15 January 2010  
Project 4954.01

Subject: Groundwater Investigation Work Plan Addendum #2  
Emeryville Industrial Court  
5885 Hollis Street  
Emeryville, California

**PROPOSED SOIL AND GROUNDWATER  
SAMPLE LOCATIONS**

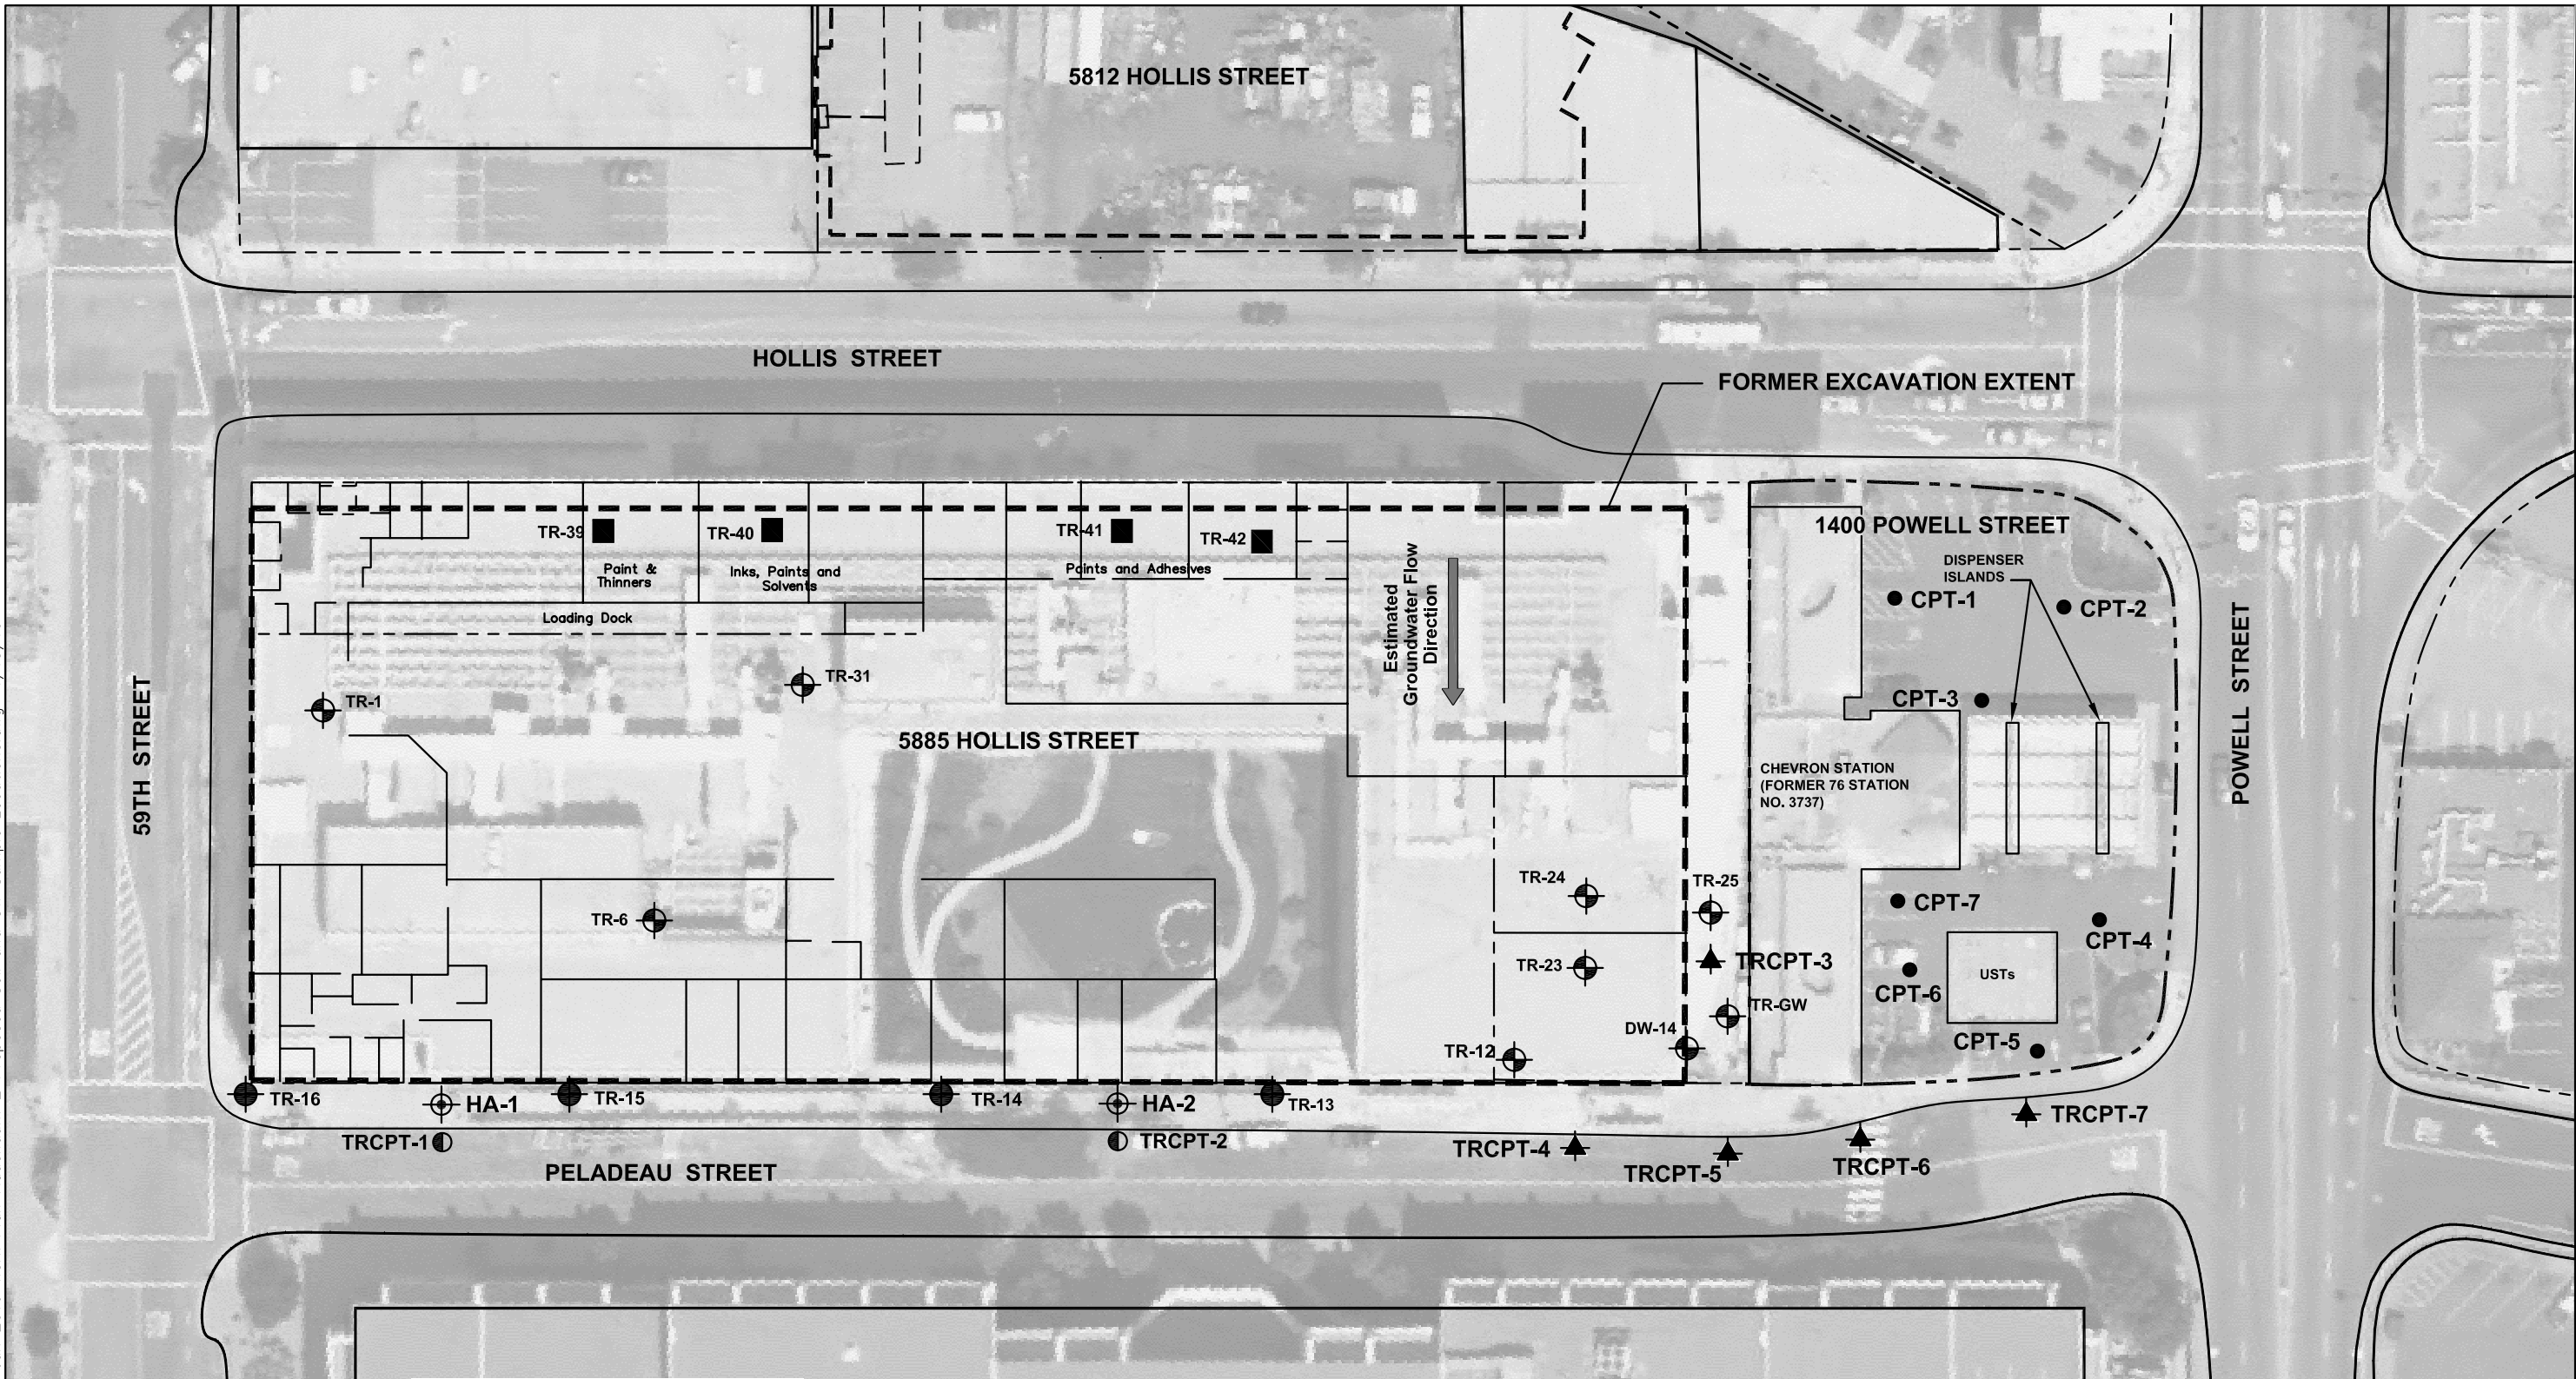
Treadwell & Rollo will collect soil samples from two locations (HA-1 and HA-2) for the purpose of characterizing the extent of benzo(a)pyrene in shallow soil. The two borings (HA-1 and HA-2) will be advanced to a depth of two feet bgs in the planter area to the south of the existing building. After the hand auger has reached two feet, a slide hammer sampler fitted with a six-inch stainless steel liner will be used to collect a soil sample from each location. The locations of HA-1 and HA-2 are shown on Figure 1.

Treadwell & Rollo will also collect soil samples from boring locations TRCPT-1 and TRCPT-2 prior to drilling activities. Prior to advancing the CPT probe, each location will be hand augered to a depth of 5 feet. Soil samples will be collected during hand augering activities using a slide hammer sampler fitted with a six-inch stainless steel liner. Soil samples will be collected from depths of 2.5 feet and 5 feet bgs. The soil sample from 2.5 feet bgs will be held by the laboratory and analyzed if the sample from 5 feet bgs detects concentrations which exceed the construction worker ESLs.
